TO: District of Columbia Zoning Commission

FROM: Brandice Elliott, ACIP, Project Manager
JLS
Jennifer Steingasser, AICP, Deputy Director
Historic Preservation and Development Review

DATE: November 15, 2019

SUBJECT: ZC 14-12E – Final Report for a Second Stage Planned Unit Development (PUD) for the North Building at 1309 5th Street, N.E. in Florida Avenue Market

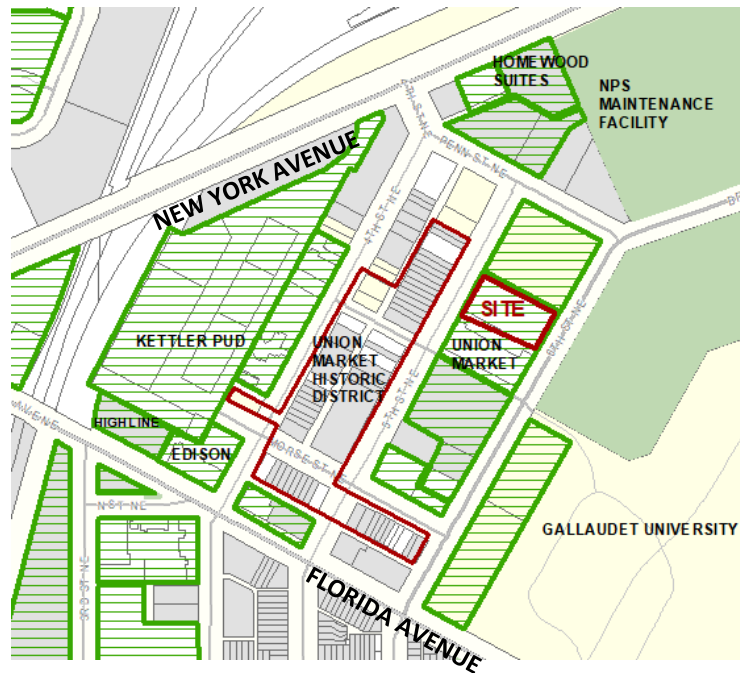
15. The width of the bay windows and balconies appear to comply with the regulations; however, the drawings are unclear in demonstrating that the balconies project within the 4-foot allowance. This information should be provided on the drawings.	The requested information has been provided.
